# EPSON PRODUCT SUPPORT BULLETIN

<b>Date:</b>	04/20/2009	<b>Originator:</b>	JAM
<b>PSB #:</b>	PSB.2009.06.001	<b>Authorization:</b>	<i>Kas</i>
<b>Reference:</b>	TI 09-05e Rev. A/B	<b>Total Pages:</b>	5
<b>Product(s):</b>	PowerLite 735c / Cinema 500 / 737c / 745c / 755c / 765c / 830p / 835p / 1705c / 1715c / 6100i / 6110i / 7800p / 7850p / 7900NL / 8300i / 8300i with EasyMP.net module / 9300NL / 1815p / 1825 / 822p / 83c / 822+ / 83+ / G5000 / Pro G5150 / Pro G5350 / Pro G5200W / 1725 / 1735W / 400W / 410W / 84 / 85 / 825 / 826W PowerLite 61p / 81p / 82c / 821p / 1810 / 260d (Latin America) / 280d (Latin America) with TCP/IP to Serial converter		
<b>Subject:</b>	Release of EMP Monitor for Windows version 4.30

EMP Monitor V4.22

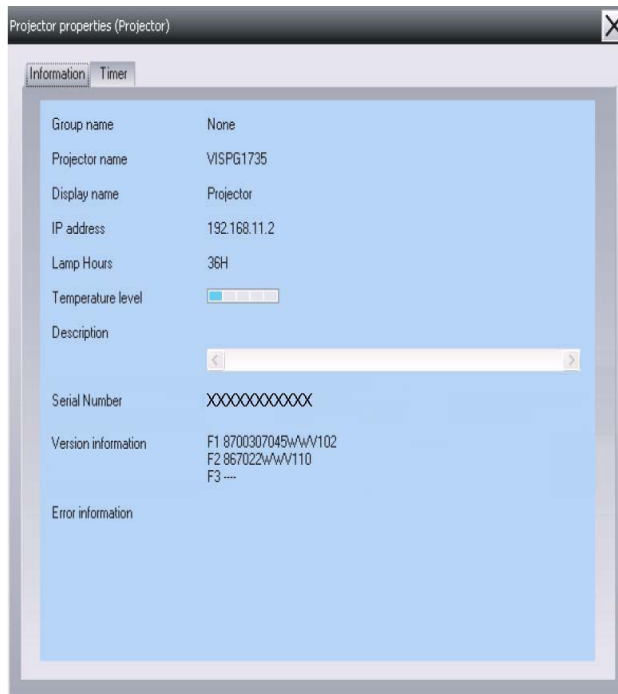
(2) Addition of Input Source (Only PowerLite 84 / 85 / 825 / 826W)  
Previous version of EMP Monitor included USB Display, USB and LAN as one source: EasyMP.

The input source buttons for USB display, USB, and LAN are available as separate input sources as shown below:
